DOCKETED	
Docket Number:	19-BSTD-03
Project Title:	2022 Energy Code Pre-Rulemaking
TN #:	237402
Document Title:	Home Ventilating Institute Comments on CEC Draft Express Terms
Description:	N/A
Filer:	System
Organization:	Home Ventilating Institute
Submitter Role:	Public
Submission Date:	4/9/2021 11:15:39 AM
Docketed Date:	4/9/2021

HVI Comment - CEC Draft Express Terms

Re: Docket No. 19-BSTD-03, 2022 Energy Code Pre-Rulemaking, Draft Express Terms

Figure 1. Some ventilating fans are designed to deliver the targeted airflow when round ducts are slightly compressed to form an oval.

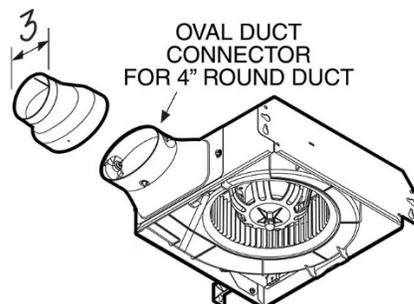
2. **150.0(m)1E and 160.3(b)5v** These sections prohibit compression of ventilation ducts within cavities. Generally, this is good practice. However, some ventilation fans are designed for compressed ducts in wall cavities. For example, some wall-mount exhaust fans accommodate 4" ducting that is slightly compressed to form an oval; such ducting has a greater hydraulic diameter than 3" ducting which would otherwise need to be used in a wall cavity to avoid compression (see image below). In this case, use of 4" round duct that is slightly compressed to form an oval can reduce static pressure, fan energy consumption, and coincident noise during fan operation. For these reasons, please consider modifying these sections as follows:

Ducts installed in cavities and support platforms shall not be compressed to cause reductions in the cross-sectional area of the ducts, except where approved by manufacturer installation instructions.
